**TOWN OF HERNDON, VIRGINIA  
ARCHITECTURAL REVIEW BOARD  
WORK SESSION AGENDA  
SEPTEMBER 4, 2019  
HERNDON COUNCIL CHAMBERS BUILDING  
765 LYNN STREET  
7:30 P.M.**

**Case Number & Type:** ARB #19-33; New Construction  
**Case Summary:** Install new drive-thru clearance bar and order canopy on the commercial property for redesign of a fast food restaurant.  
**Case Location:** 1071 Elden Street, McDonald's

Welcome Point Gateway - Charcoal 2PC

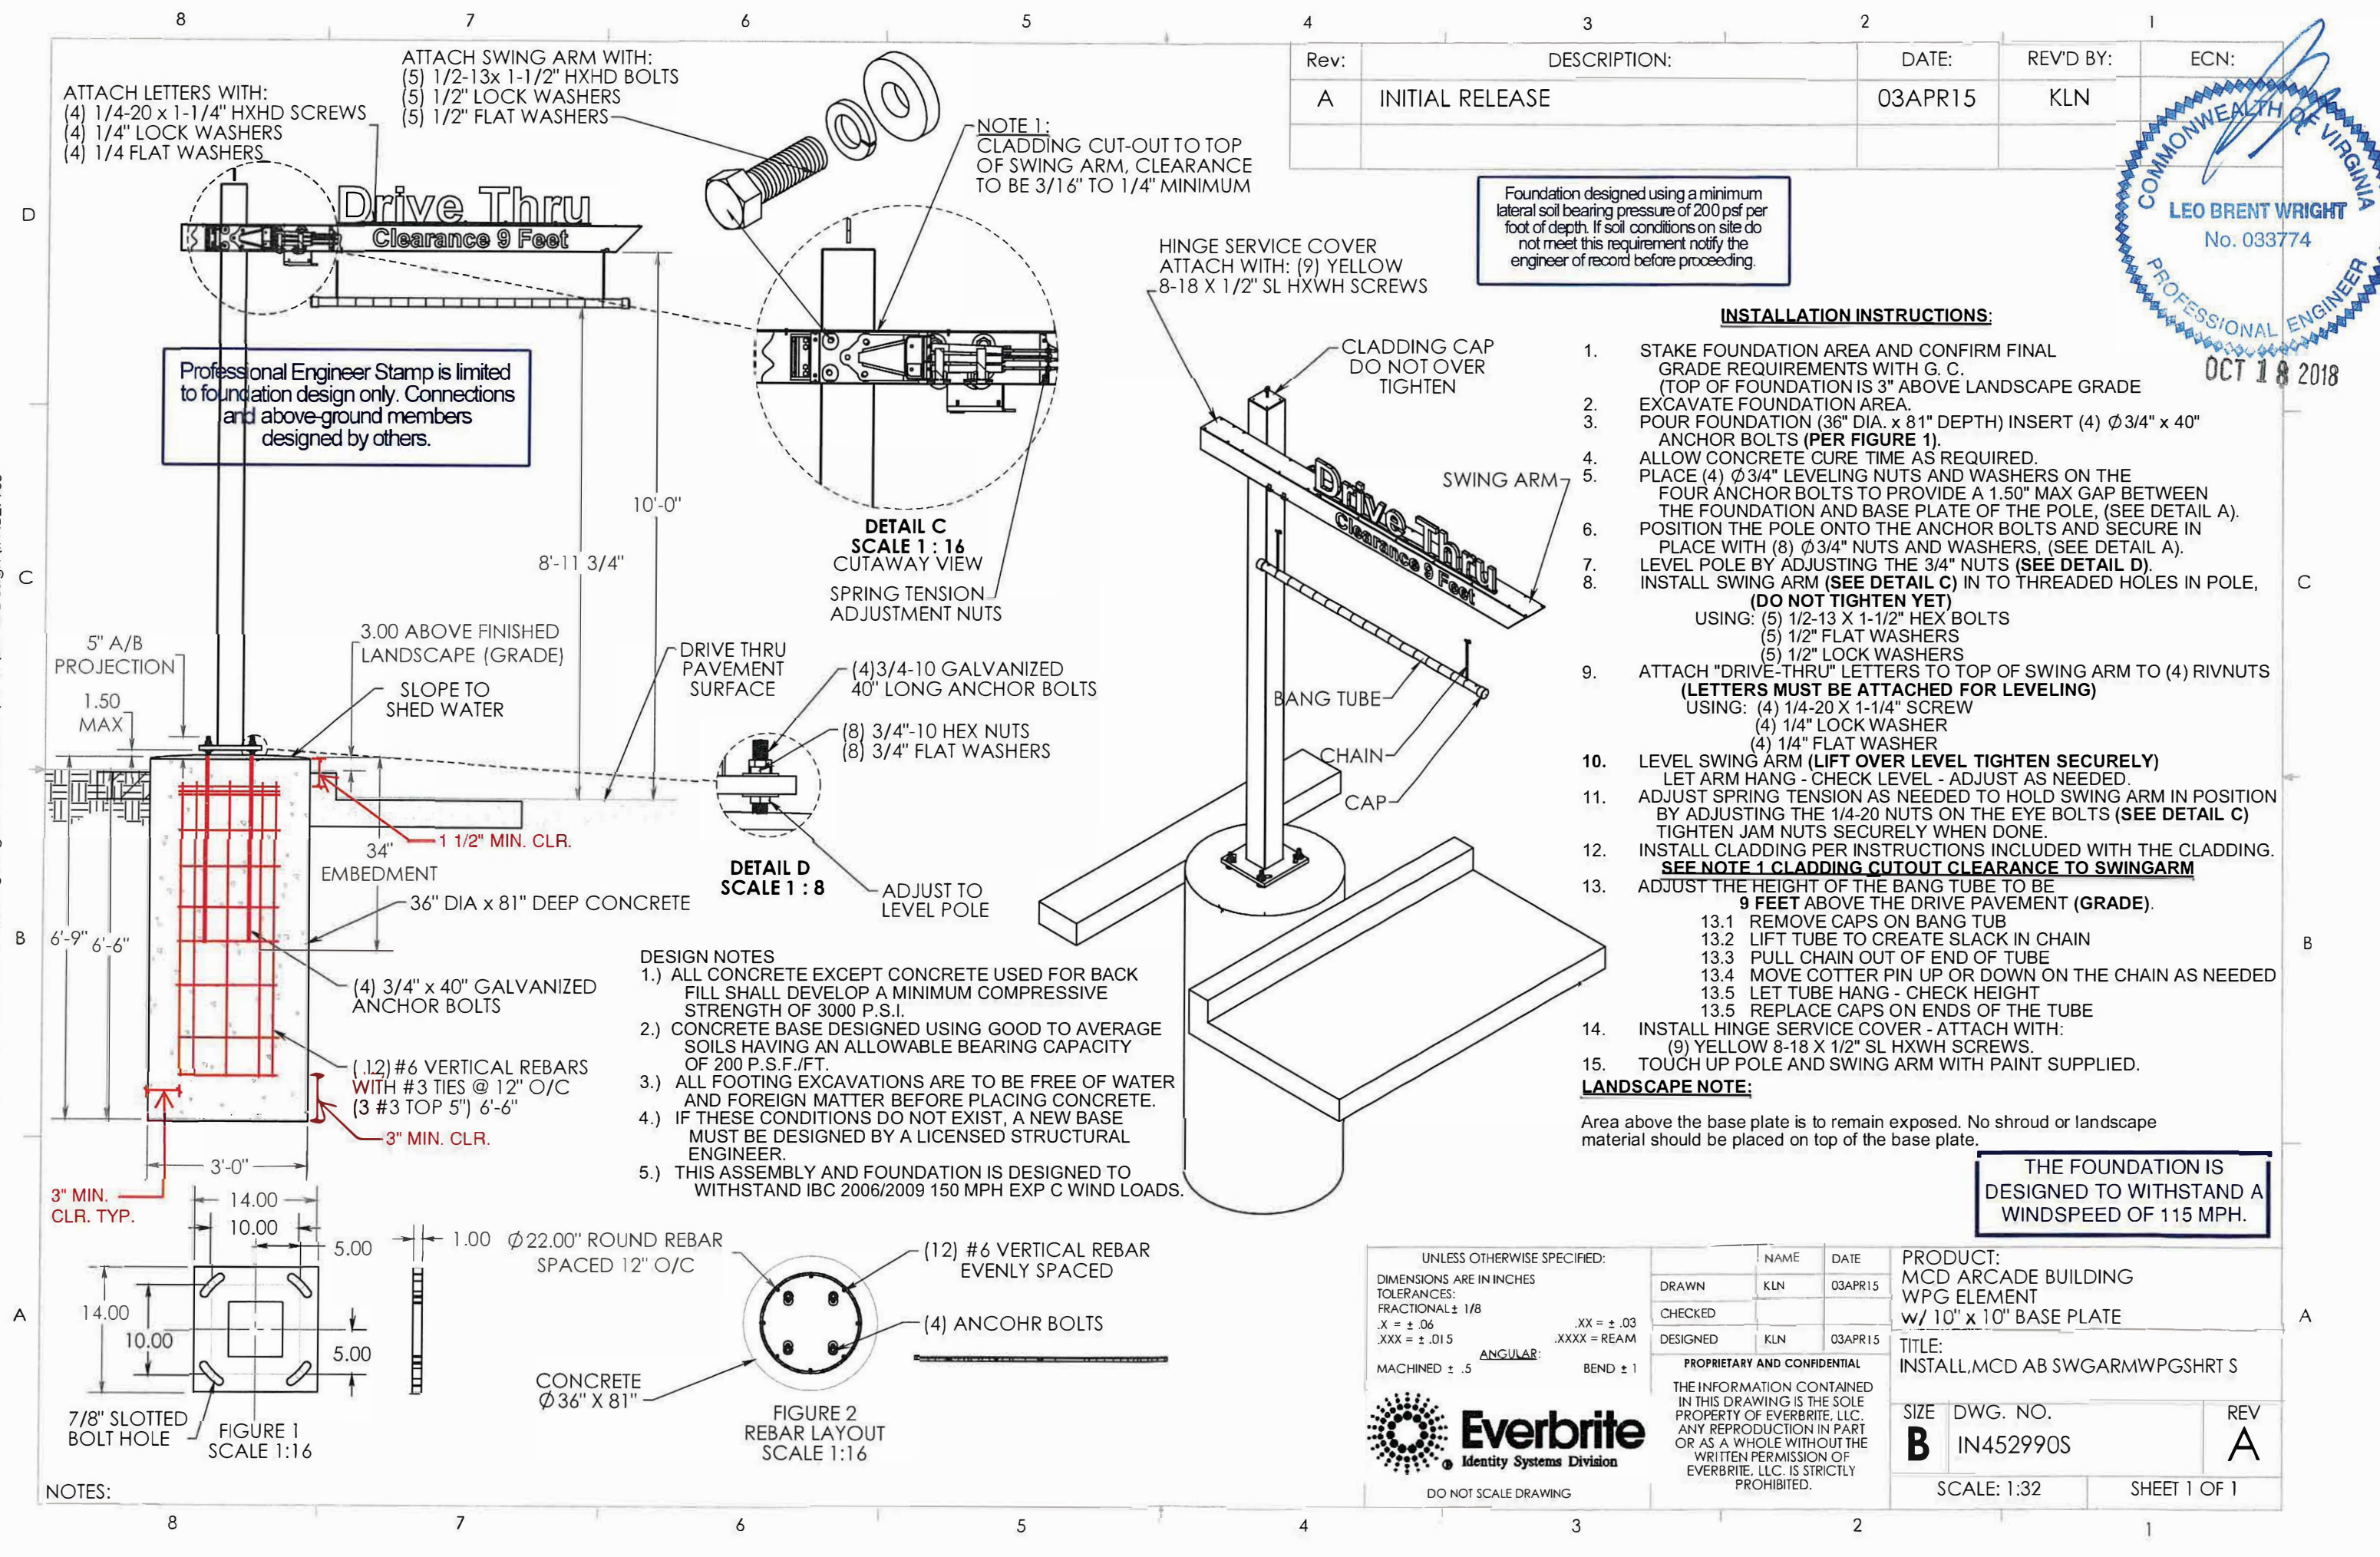
1. The proposed “*Drive-Thru*” lettering to be mounted on the clearance bar on the proposed structures does not meet the Town Zoning Ordinance, Section, 78-140.5. - *Sign license required* (n)(6) regarding minor signs that do not require a sign license and therefore do not require Board review or approval. In this case, a minor sign may be a wall or freestanding sign that has a sign area of two (2) square feet or less. As noted, the “*Drive-Thru*” lettering will have an area of 3.1 square feet. Due to the noncompliant lettering size / area, the Board may not act on this application until this sign meets the zoning ordinance requirement for a minor sign, otherwise this feature becomes a different sign type that is not permitted in the CS zoning district. The applicant may resubmit a revised sign design that complies with the referenced zoning ordinance section and has an area of two (2) square feet or less.

If the applicant can revise the mounted lettering design and resubmit design materials to staff no later than September 11, 2019, staff will have the opportunity to review and update its recommendations potentially enabling the Board to act on the case at the September 18, 2019 ARB Public Hearing.

| <b>Recommended Motion:</b>  | Motion for continuance of ARB #19-33, in accordance with Alternative #4, to address the following: <ol style="list-style-type: none"><li>1. Revise the ARB #19-33 application, as needed, and the staff recommendations upon resolution of the compliance with the referenced zoning ordinance standards.</li></ol>                                                 |
